## APPLICATION FOR VARIANCE Municipal Code of Ordinances

PHYSICAL ADDRESS: 108 W. Main Street, Johnson City, TX 78636

**RE: Johnson City Coffee Co Parking Lot Paving**

**From:** Rick Schroder  
**Sent:** Sunday, January 22, 2023 12:01 PM  
**To:** Sara Allen <sara@titanmillinginc.com>  
**Cc:** Nancy Woodward <nrwoodward@gmail.com>; Stephanie Fisher <sfisher@johnsoncitytx.org>; Odalys Johnson <ojohnson@quiddity.com>  
**Subject:** RE: Johnson City Coffee Co. Driveway / Parking Lot

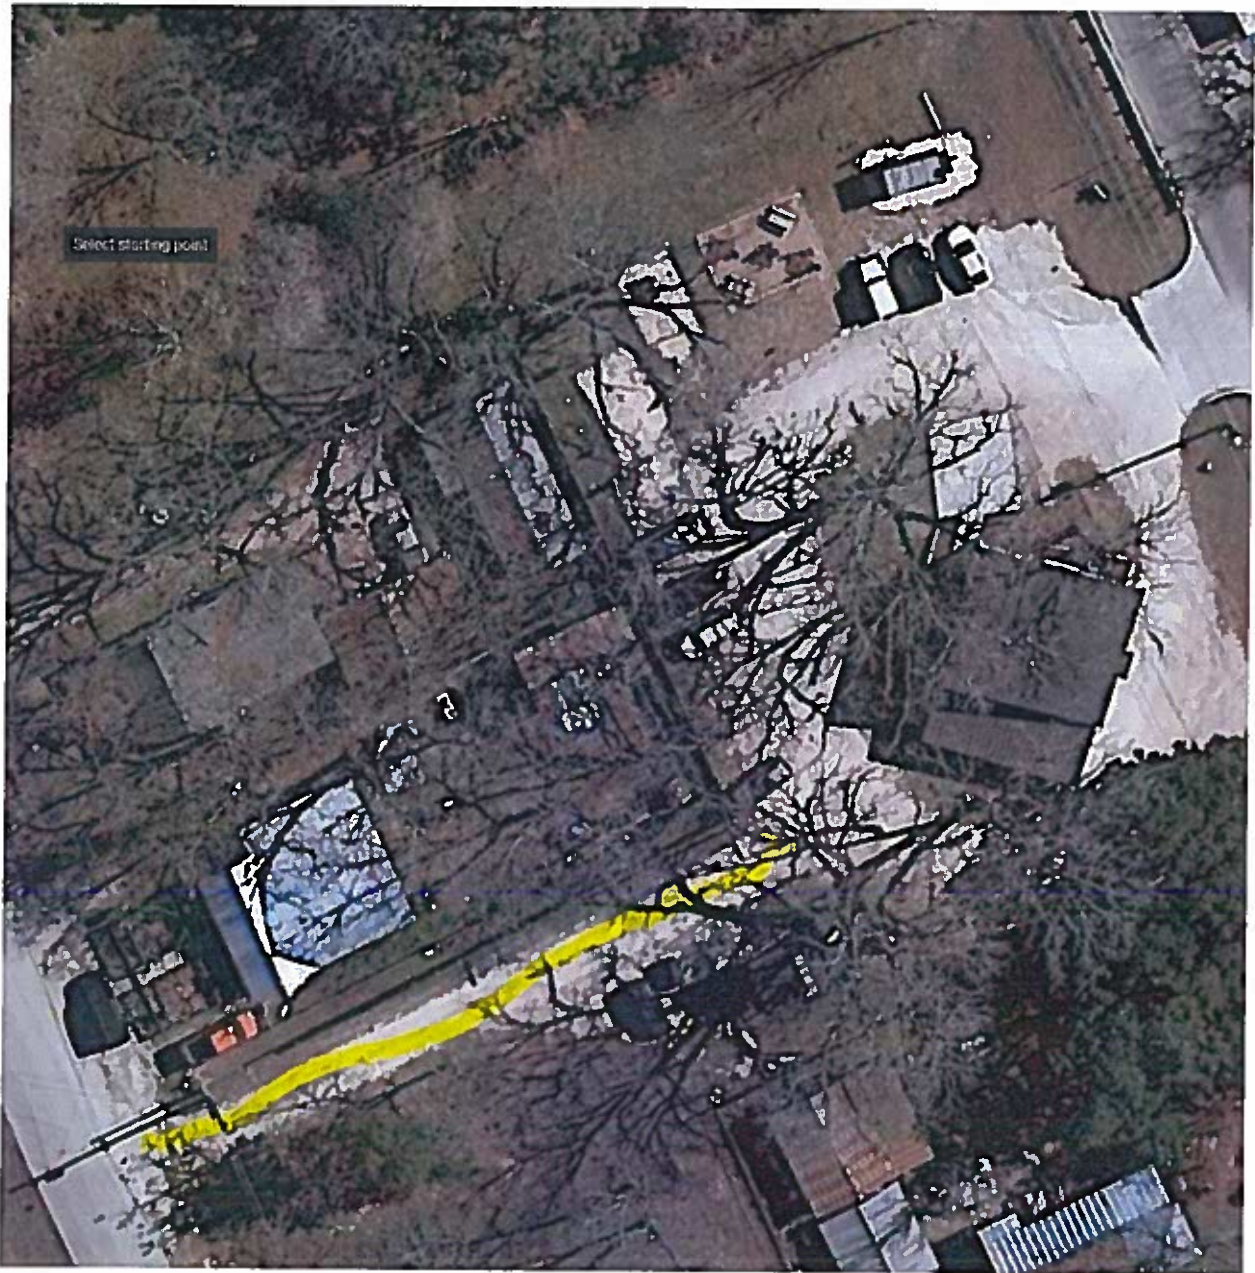
I understand the concept, but without plans we can't corroborate that they build the driveway following the grade. There is drainage that comes from the west that should be conveyed in that swale until it makes it into Town Creek. If the driveway is built high and the swale is blocked drainage could pond at the road, or impact other properties. It is hard to say without plans. I believe there is already some sort of driveway in place, so I was wondering if that has created a drainage issue already. Yes, I was referring to the screening requirements you referenced below.

It is also hard to determine if the 18' width they are proposing and the 20' minimum radii requirement can be met without a plan. I believe the Code also requires landscaping buffer along the driveway so we would need to make sure they are allowing enough space from the fence for that.

The area highlighted is the only portion of this paving project that is not included in the initial permit. There is no culvert being installed since it would affect the current flow of runoff, instead it is a cement apron similar to a low water crossing so no drainage is affected. No easements are needed as it is far enough from the property line.

Thank you for your patience. Unfortunately, since the rear driveway was not in the originally approved site plan, we ask that you provide the following information for our review before moving forward with paving the driveway:

1. Grading plan showing the driveway layout with dimensions, the proposed culvert, the constraints mentioned below and any others such as easements, etc. Please reference the sections of the [City's Design Standards](#) listed below and include the applicable standard details on the plan:
  - a. Pg. 18 – 2.14(B)
  - b. Pg. 19 – 2.17
  - c. Pg. 20 – 2.18 (D)(1) & (G)
  - d. Pg. 83

2. Drainage calculations to verify the size of the culvert.
